re: Excavation Review

Proposed Building Demolition

95 Melrose Avenue, Ottawa, Ontario

file: PG7474-MEMO.01

EXCAVATION PROFILE - SECTION A

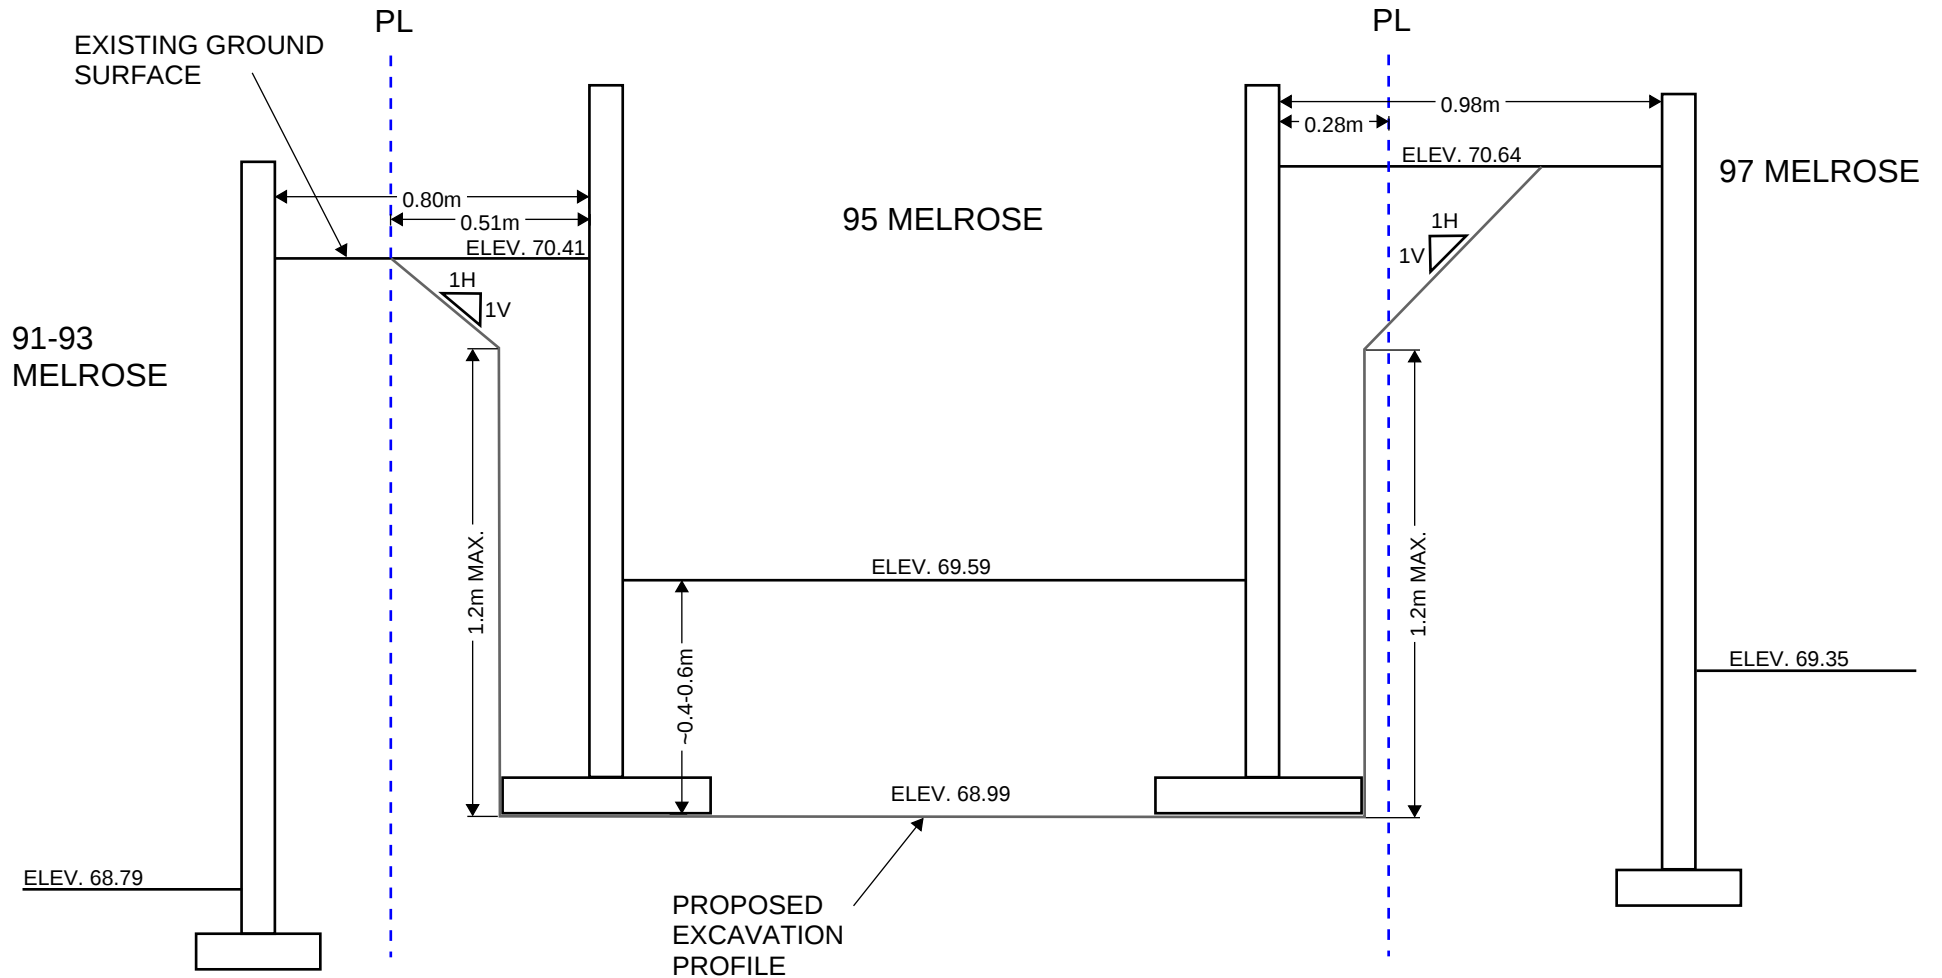
- *Where proposing a sloped excavation, plan of excavation including gradient.*

See attached cross-section A-A and B-B in the Excavation Plan & Details drawing attached for the sloping details.
